DESCRIPTIVE REPORT TO ACCOMPANY HYDRO. FIELD SHEET #9, STATION CREEK, TRENCHARDS INLET, STORY RIVER, SOUTH CAROLINA. H&T PROJECT #160.

Hydrographic Sheet H 5517 (field number 9) Reference your letter of Jan. 12, 1935, 80-DRM

REVIEW OF HYDROGRAPHIC SURVEY NO. 5517 (1934)

Trenchard Inlet, Port Royal Sound, S. Carolina Instructions dated November 2, 1933 (Natoma) Surveyed in 1934

Subject: Hydrographic sheet H 5517 (field number 9).

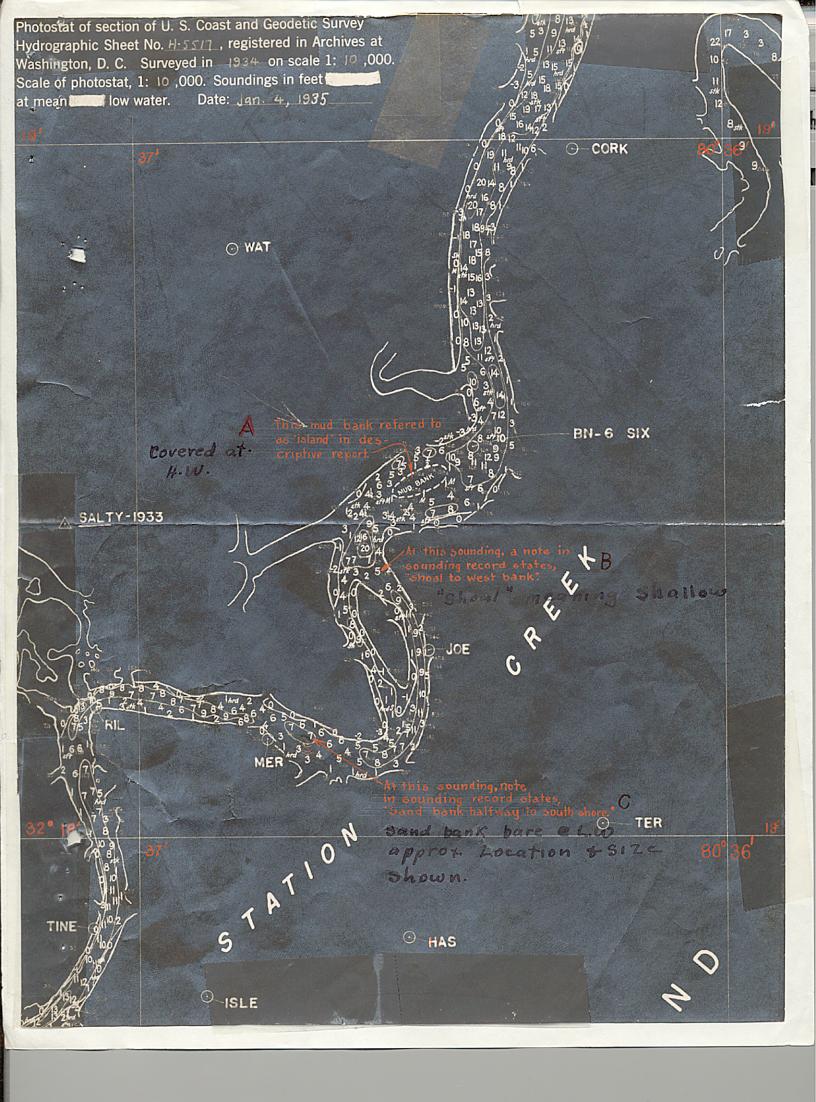
There is inclosed herewith a photostat of a section of hydrographic sheet H 5517 (field number 9) on which three areas are indicated. Area A, which carries the notation "Mud bank" on the sheet, is referred to in the descriptive report as an island. The air photo does not clearly define this feature. Please advise whether this area is a high water feature.

At areas B and C the records refer to "Shoal" and "Sand bank" respectively. In neither case are these features shown on either the boat or smooth sheet. Please indicate on the inclosed photostat the necessary information to properly show these features.

Receipt of your letter of Jan. 12, 1935 ref. number 80-DRM is hereby acknowledged. The photostat of a section of sheet H 5517 is enclosed and returned.

as area A on the enclosed photostat is covered at High Water. At area B the word shoal does not refer to the existence of a shoal but means shallow water. The sounding line is run on the northeast edge of an area of shallow water which extends all the way to the west bank. At area C there is a small sand bank which bares at low water. This note was put in the record book so that at a later date this shoal could be accurately located. Unfortunately this was overlocked. To the best knowledge of the hydrographer who did this area this sand bank has been spotted in red pencil on the photostat. It is believed that this spotting is fairly accurate.
